**PRODUCT NOTICE**

PlantPax 5.0 Execution Anomaly with PVLV Instruction When Controller Transitions from Program to Run

Reference: 2021-03-002

– Temporary Workarounds –

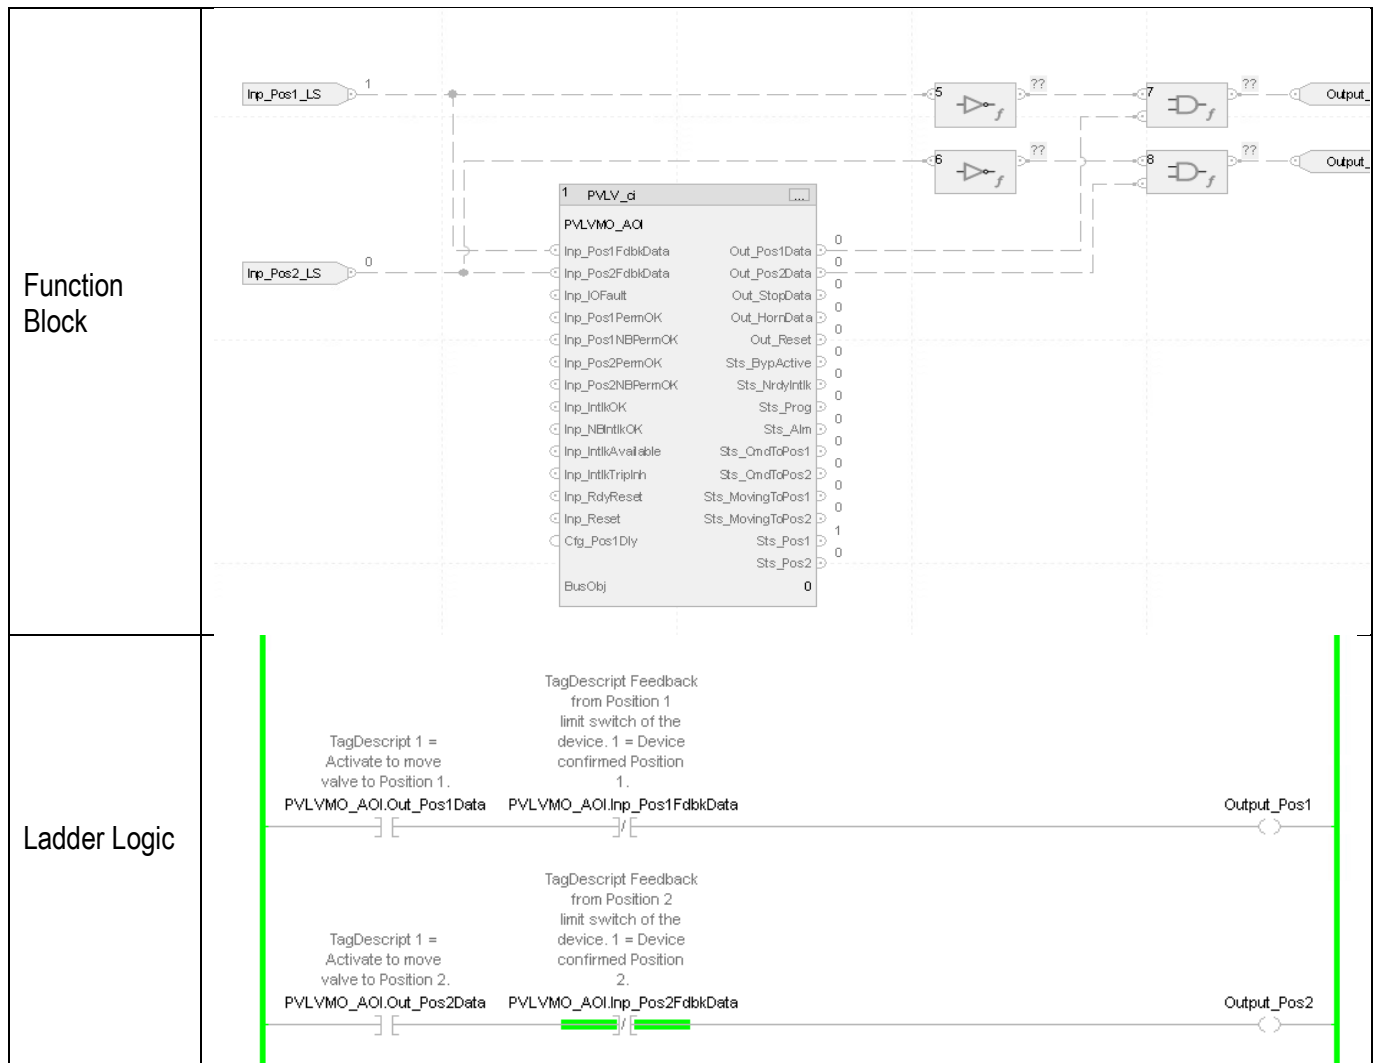
PVLV – Incorrect operation when controller transitions from Program to Run. Output to device is incorrectly generated when the controller is transitioned from Program to Run status. Expected behavior is that the PVLV function should not produce any output when the valve is at rest in the selected position unless there is an operator or program command to do so. This anomaly can specifically cause equipment damage when applying the PVLV instruction to motorized valves.

The workaround is to apply external logic (as shown below) to disable any errant signal from the PVLV instruction being propagated to the field.
